PLAT COMMITTEE

Case Number: 2025-PLT-056
Property Address: 10009 East Washington Street (*Approximate Address*)
Location: Warren Township, Council District #20
Petitioner: Washington Shoppes, LP, by Tracy L. McGill
Zoning: C-4 (TOD)
Request: Approval of a Subdivision Plat, to be known as Washington Shoppes Outlot Minor Plat, dividing 7.174 acres into two lots.
Waiver Requested: None
Current Land Use: Commercial retail and surface parking
Staff Reviewer: Jeffrey York, Manager

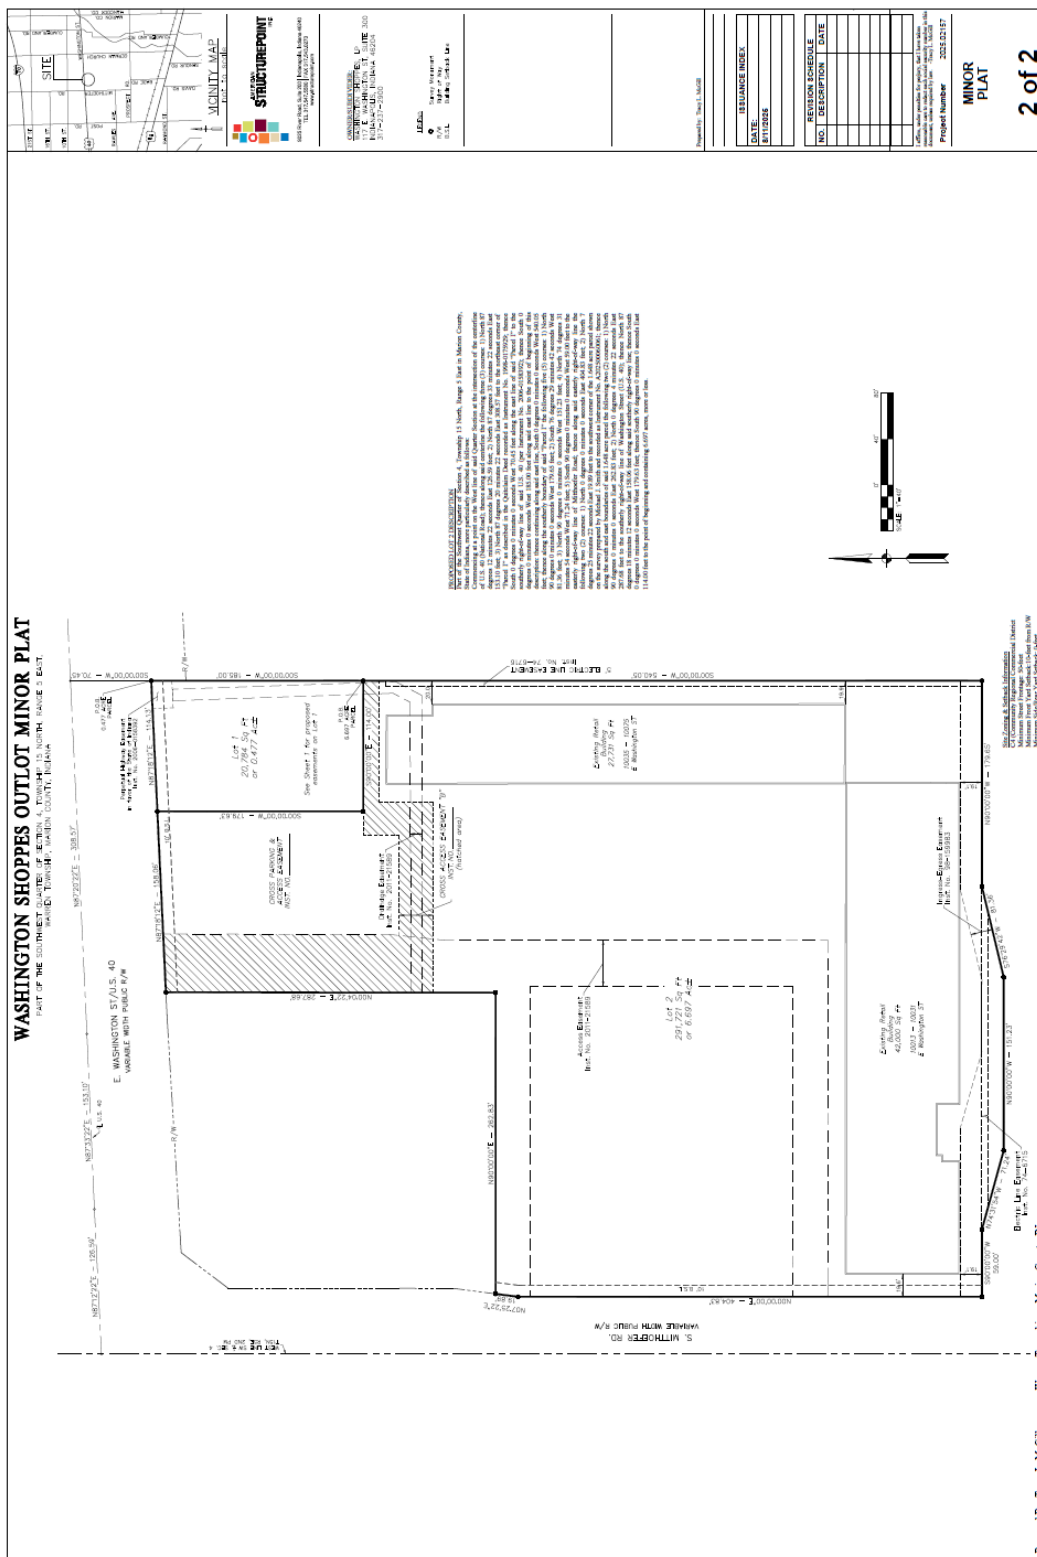
Sidewalks exist along Washington Street. Sidewalks do not exist along Mitthoefer Road but are required.
